Access Compliance Report

Public Rights-of-Way

| Intersection ID: 48312 | Main Street: ROCKY_BROOK_CT | Cross Street: TRILLIUM_FIELDS_DR | Location: SE |
| ADA ID: C9BA7258A50B | Ramp Type: Perp | Initial Pass/Fail: Pass | Overall Compliance: No |

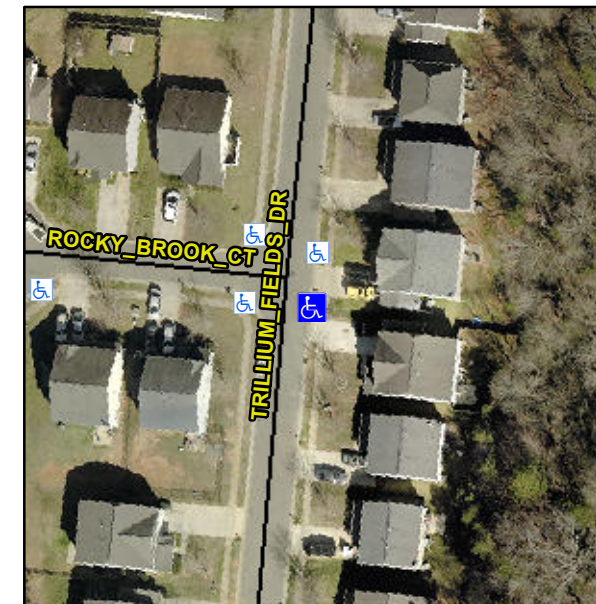
R304.5.3, R304.2.1, R305.2

| Compliance | Description | Data | Compliance | Description | Data |
|------------|-----------------------|--------|------------|-----------------------------|------|
| Yes | Ramp Width (in) | 48.0 | No | Ramp XSlope (%) | 4.5 |
| No | Landing Length (in) | 47.5 | Yes | DWS Provided? | Yes |
| N/A | Landing Curb? (Y/N) | No | No | DWS Offset (in) | 4.0 |

Remove & Replace Entire Ramp.
